UNITED STATES PATENT AND TRADEMARK OFFICE

APPLICATION NO.	FILING DATE	FIRST NAMED INVENTOR	ATTORNEY DOCKET NO.	CONFIRMATION NO.
09/784,827	02/15/2001	Colm J. Prendergast	AD-217J	5800

# Office Action Summary

FIG. 5

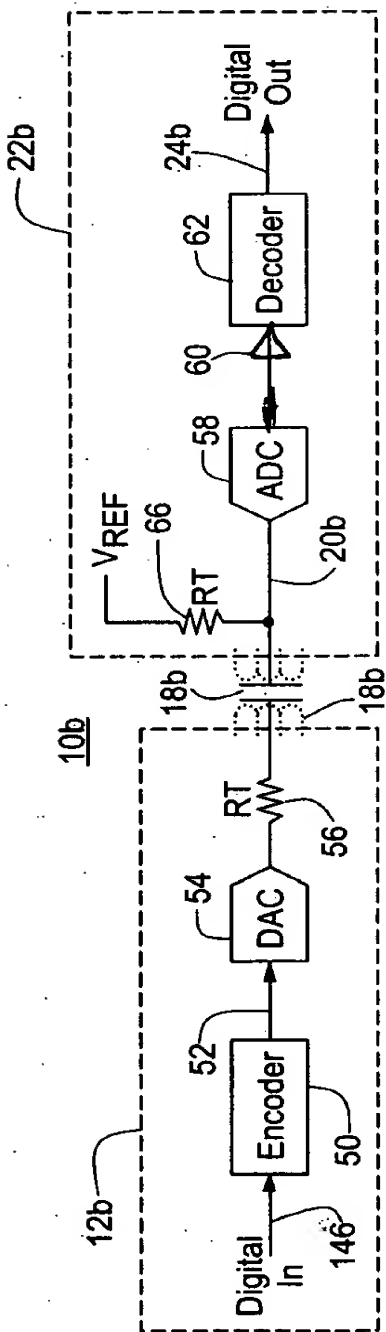
2. In Fig. 5, the direction of element 60 should be **reversed**. A marked-up copy of the drawing in red ink is enclosed.
